COLUMBIA BOROUGH PLANNING COMMISSION

Paul W. Myers Council Chamber, 308 Locust Street, Columbia December 20, 2022 – 7:00 p.m. Final Agenda

FINAL SUBDIVISION / LAND DEVELOPMENT PLAN LANCASTER LEBANON HABITAT FOR HUMANITY

Advisory Plan Review Comments

NOTES / LEGEND

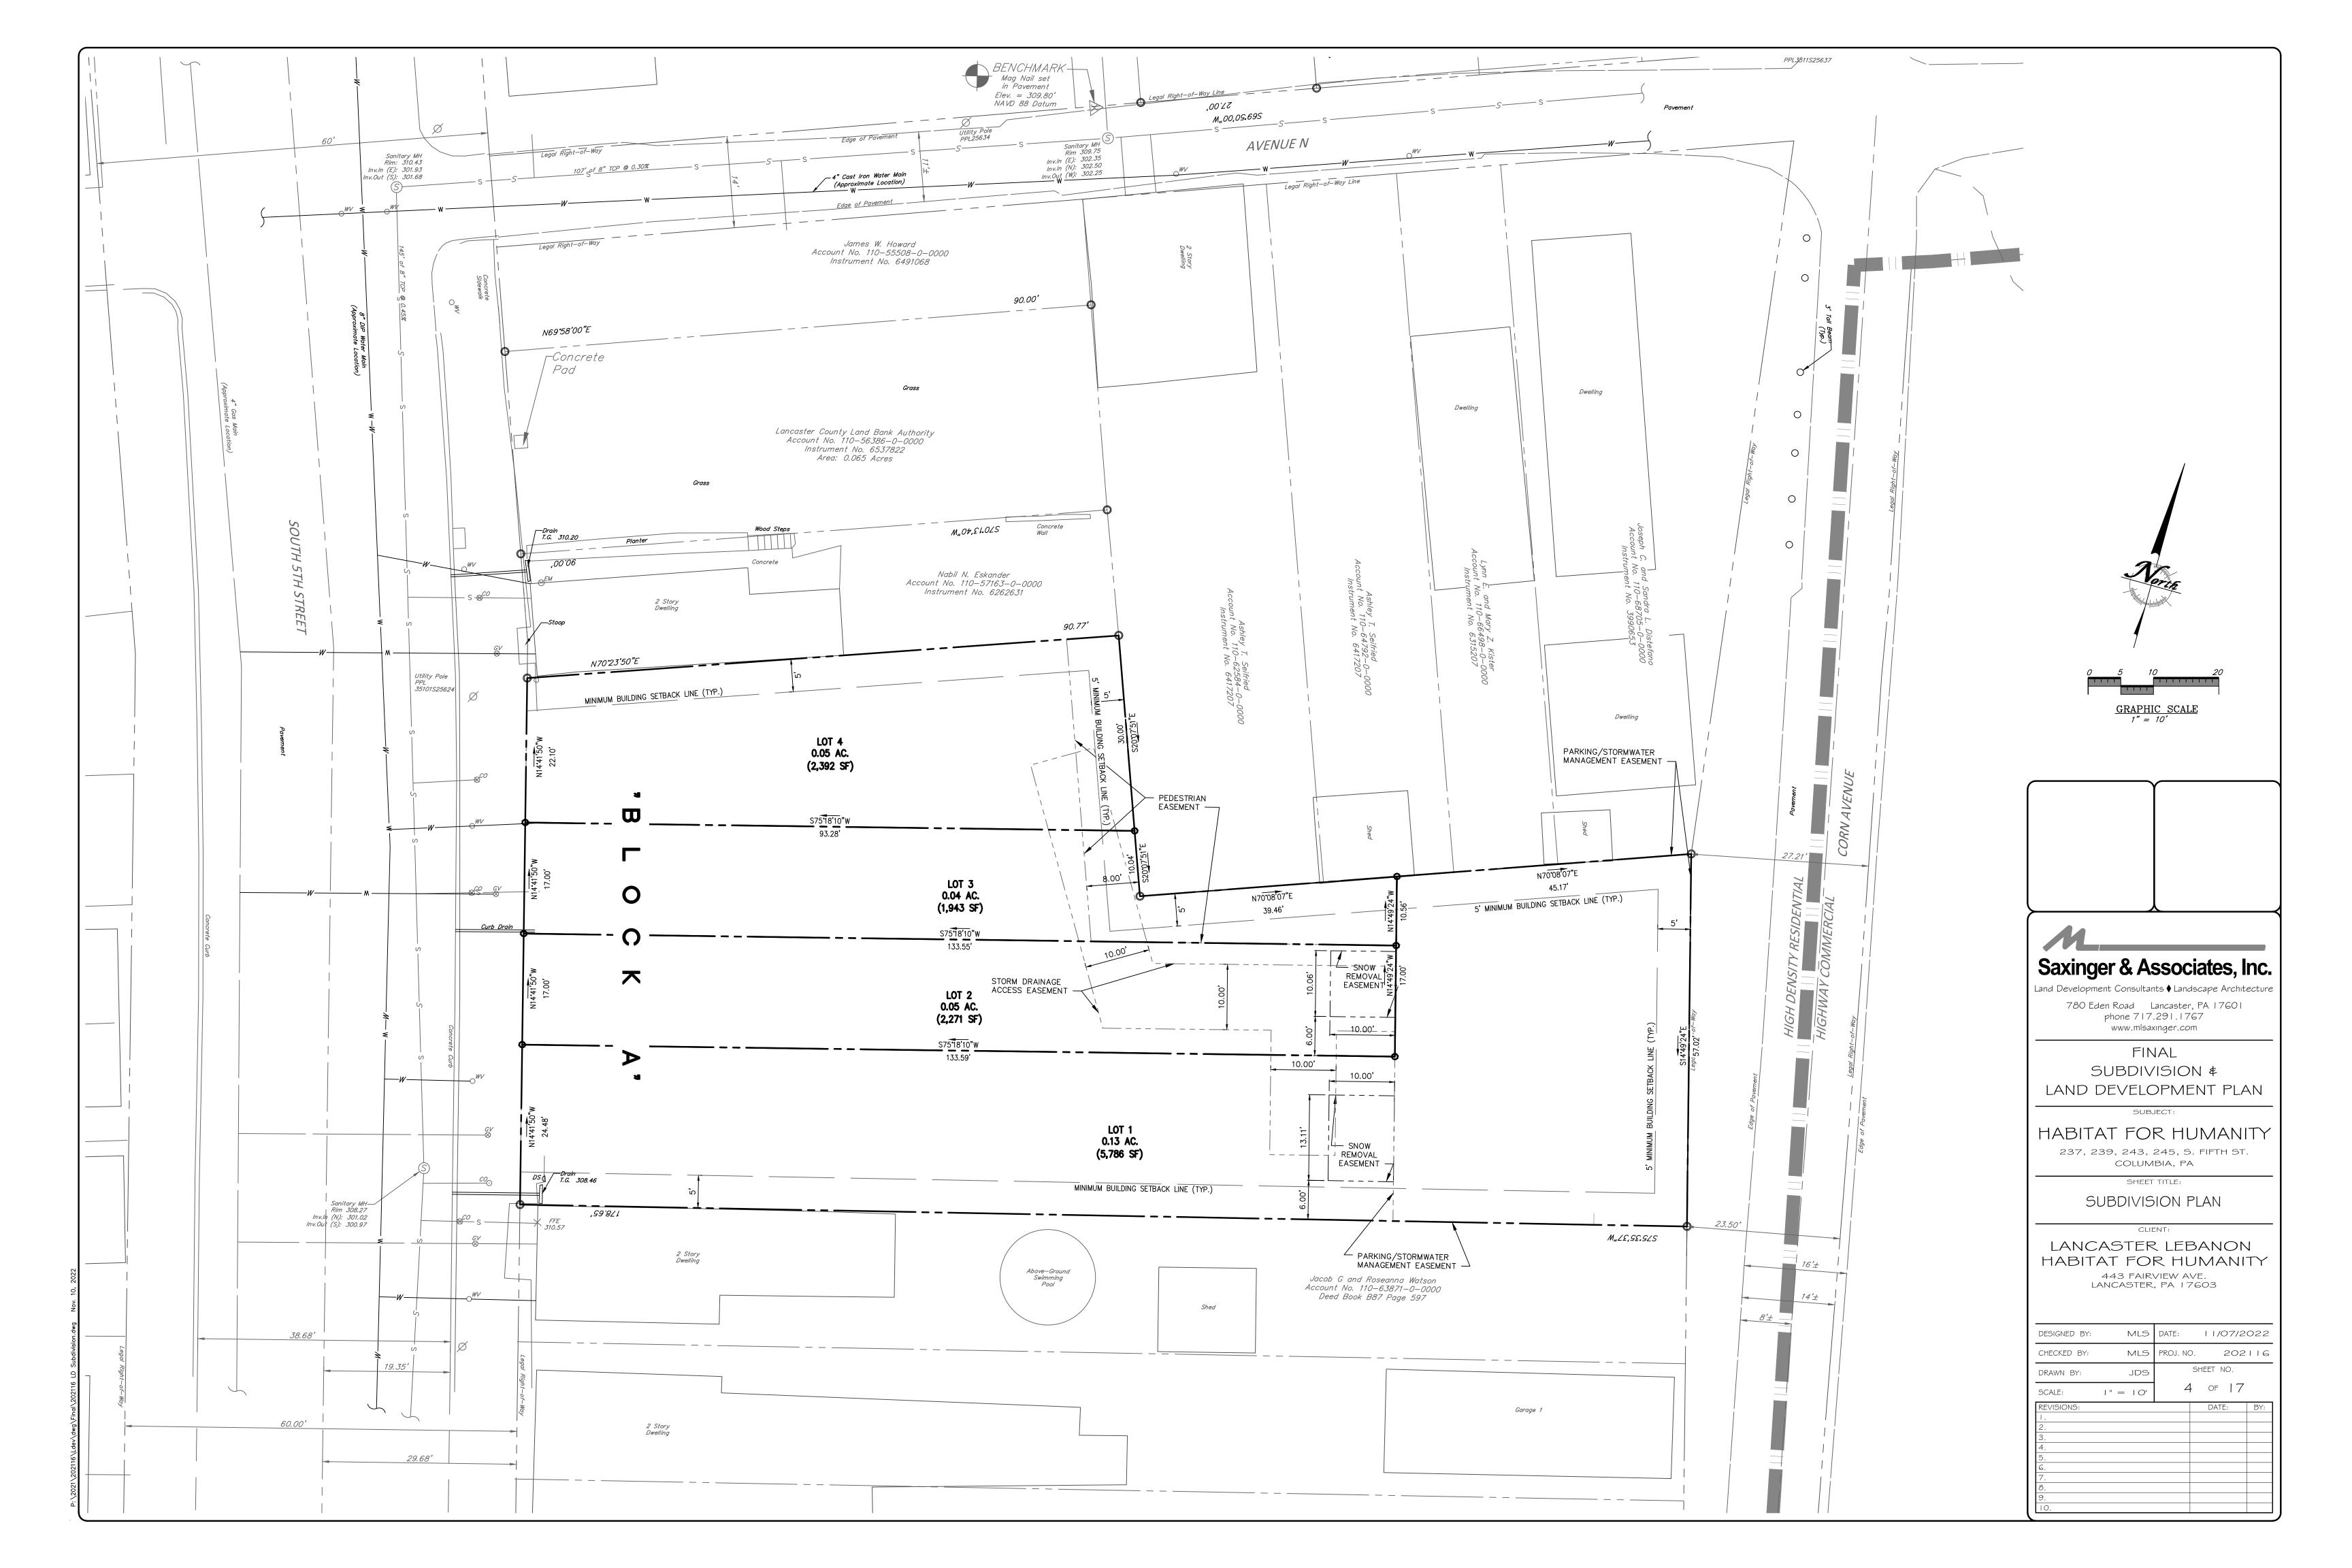
- County records identify the Tax Account # of Lot 2 as 1106361600000, not 1106339100000. Owner information on Sheet 1 of 17 should be confirmed and corrected on the plans to be recorded.
- 2. Revised deeds for the resultant lots should be recorded as part of this plan approval.
